Amendments to the Drawings

Remarks

GEMFIRE c/o Haynes Beffel & Wolfeld LLP P.O. Box 366 Half Moon Bay, CA 94019 (650) 712-0340 phone Inventors: van der Vliet
Title: Optical Splitter with Tapered Multimode
Interference Waveguide
Application No. 10/521,086
Attorney Docket No. GEML 4793-3

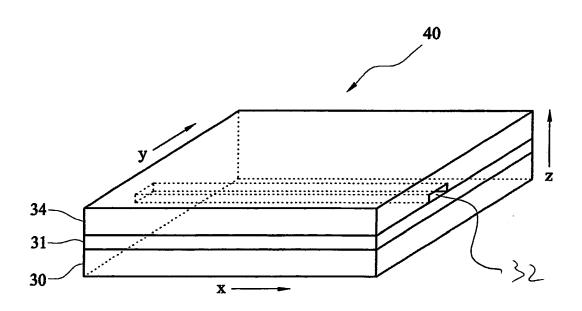
The attached sheet of drawings includes changes to Fig. 9. This sheet, which includes Figs. 8 and 9, replaces the original sheet including Figs. 8 and 9. In Figure 9, previously omitted element 32 has been added.

The Examiner has objected to the drawings as failing to comply with 37 C.F.R. §1.84(p)(5) because they do not include the following reference sign mentioned in the description: "silica cores 32."

This has been corrected by adding the reference sign in Fig. 9. The designation was included in the informal drawings filed with the original PCT application but was accidentally omitted from the formal version of the drawings.
